This bulletin supercedes No. 538

CHAIN HOUSING SEAL AND VENT PARTS-ELECTRA GLIDE

CHAIN HOUSING VENT - ELECTRA GLIDE**PARTS LIST:**

**LOCATION OF CHAIN HOUSING FITTING**

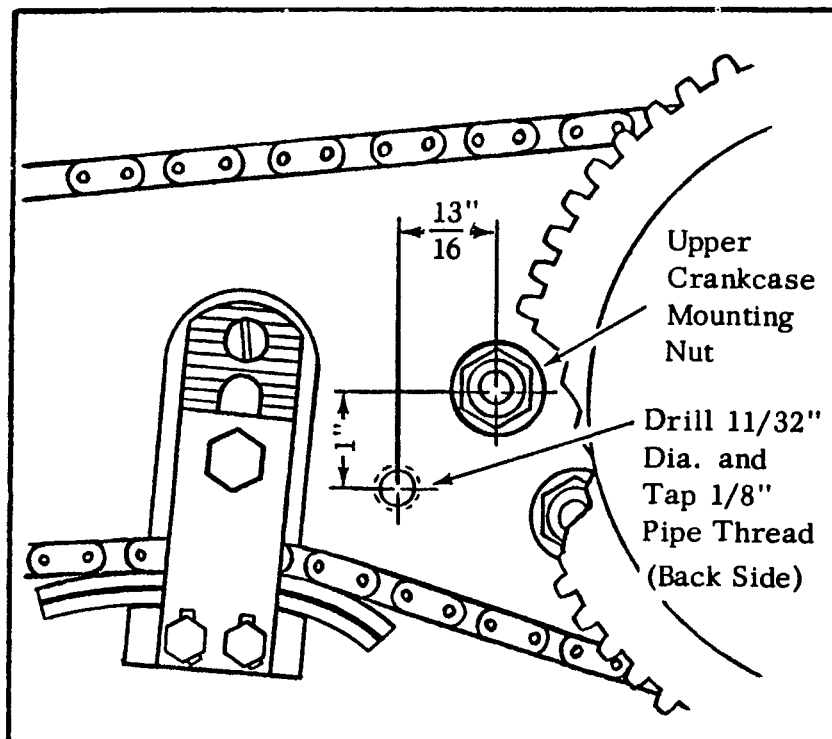
Disconnect battery negative cable. Remove front chain housing cover, chain, clutch, engine sprocket and chain housing as described in Service Manual section 3A. Drill and tap hole in back side of chain housing for hose fitting. Locate hole as shown in diagram below. Install hose nipple and install medium-length hose on nipple. Use pincer type pliers, Part No. 97087-65 to tighten hose clamp on nipple.
